**SUBJECT: BILLS 136 (2025) AND 137 (2025), RELATING TO THE  
RENOVATION OF 60 SOUTH CHURCH STREET, WAILUKU,  
HAWAII (BFED-8)**

**PROJECT:** 60 S. Church St.  
**SUBJECT:** Waterproofing

**SUBJECT: MOISTURE REPORT – 60 S Church Street-Lower Roof**

Figure 1-The areas shaded in blue were found to contain moisture.

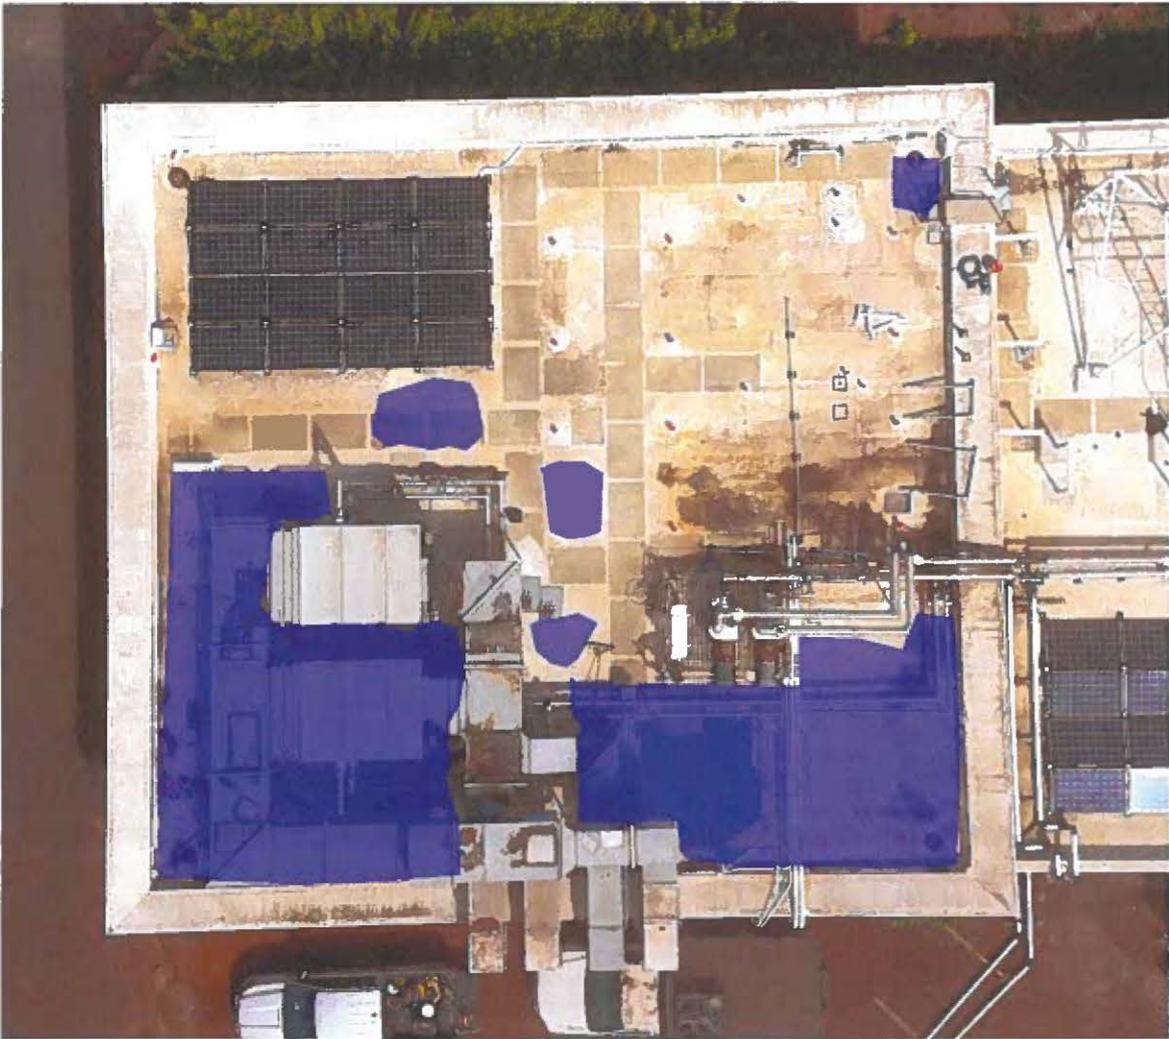
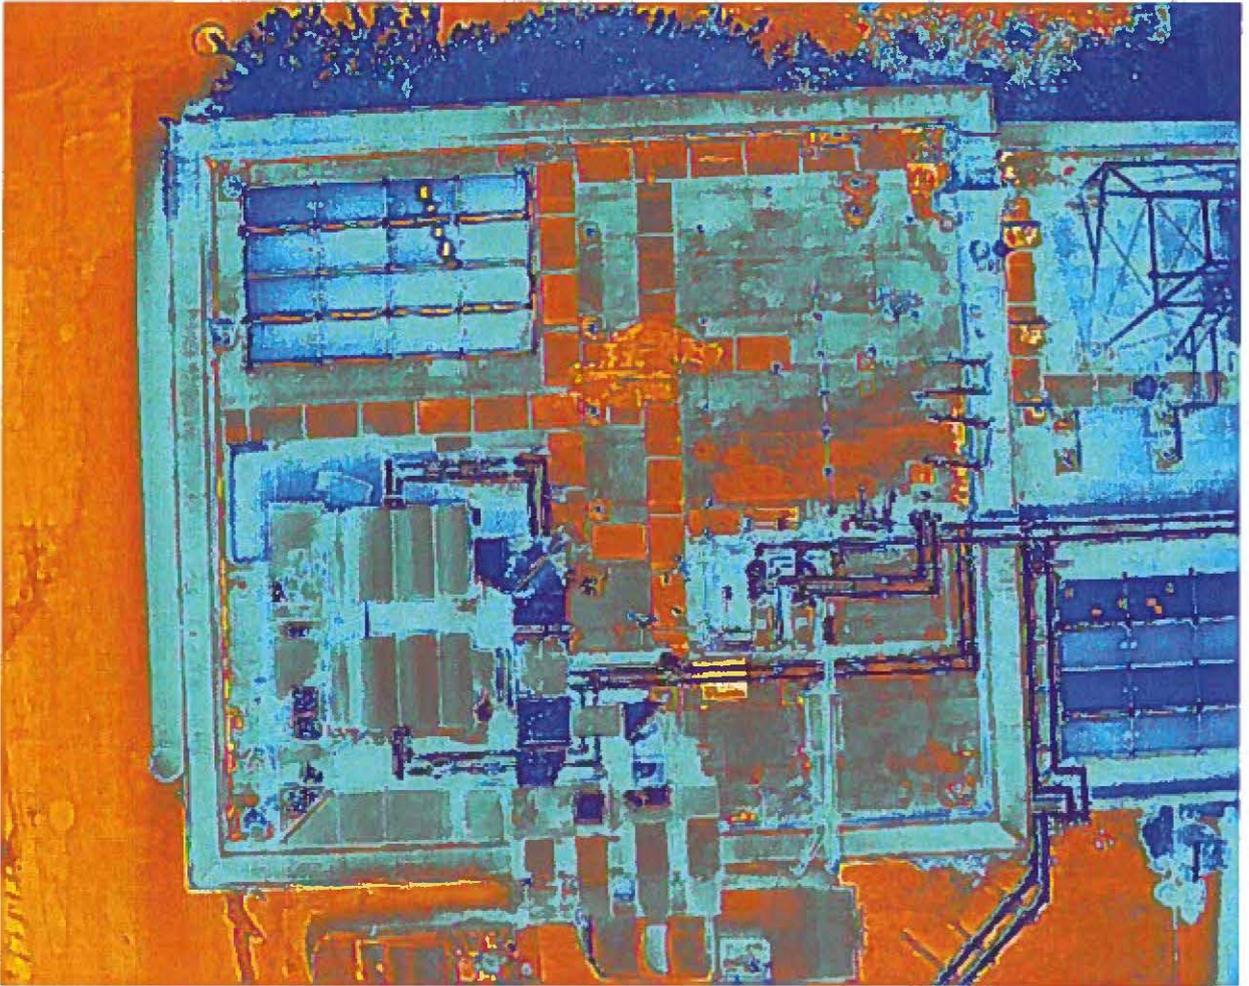
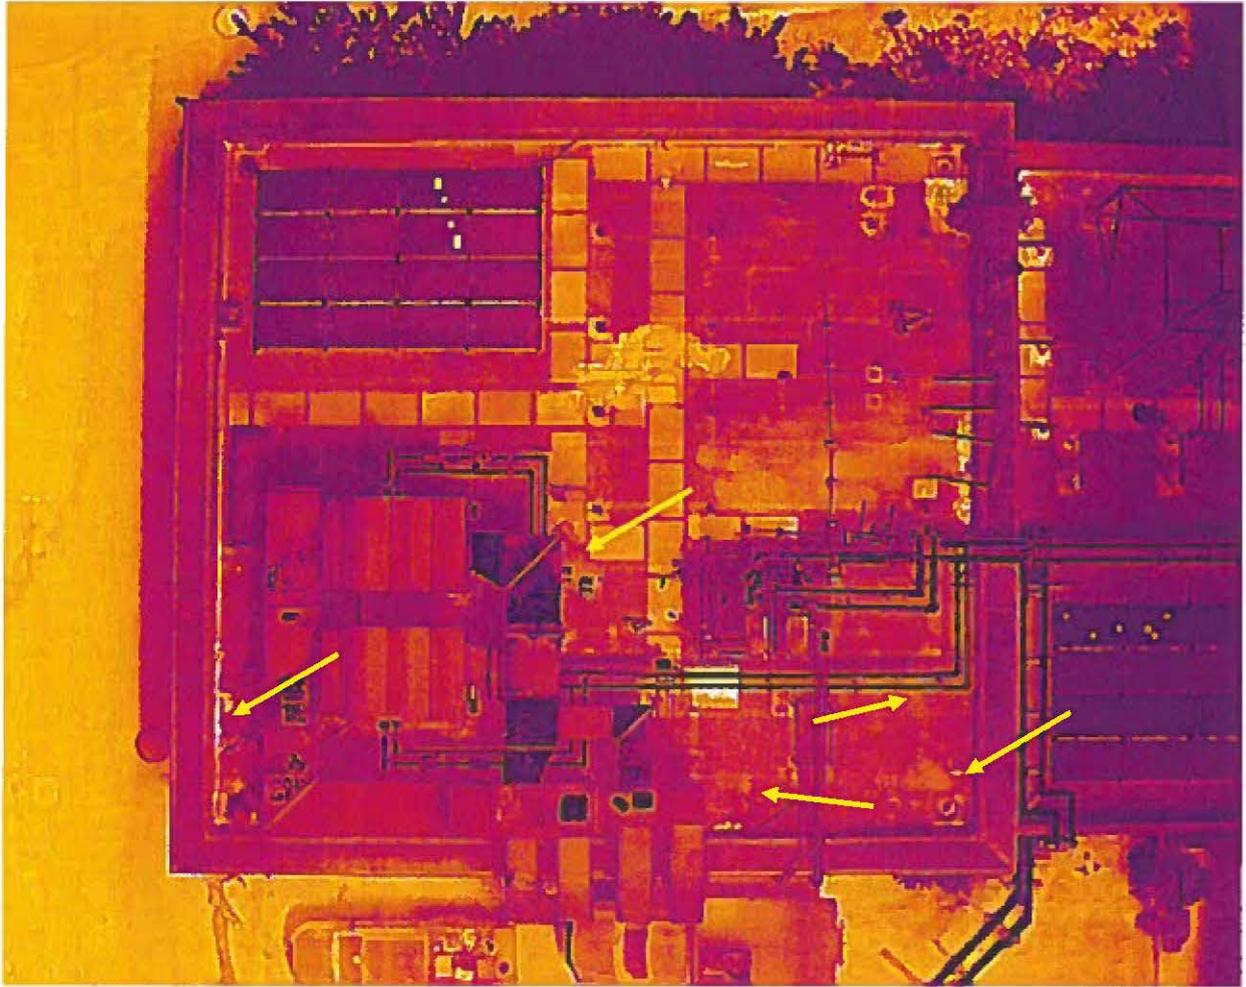
The Hypalon single ply membrane installed over the mechanical building exhibits significant signs of aging. The membrane is notably dry, with perceptible cracking underfoot—typical indicators of a Hypalon system that has been in service for an extended duration. Following the thermal survey, a Tramex RWS Impedance scanner was utilized to confirm thermal anomalies and assess the presence of moisture within the roofing system. Results indicate that approximately 60% of the roof remains dry, while the remaining areas registered a consistent 100% reading on the Tramex gauge, suggesting elevated moisture levels. The region beneath the currently operational chiller unit appears to contain the majority of this moisture. Additionally, ceiling observations from below this area provide clear evidence of moisture intrusion.

Due to the amount of moisture in the roof it is advisable to remove all the wet sections through the insulation layer. In lieu of replacing the Hypalon membrane a peel and stick membrane may be used once the insulation has been replaced. ASC (AMERICAN STANDARD COATINGS) will allow a 50 mil application to be applied over the top of the Hypalon membrane including the peel and stick which will then be warranted for 20 years.
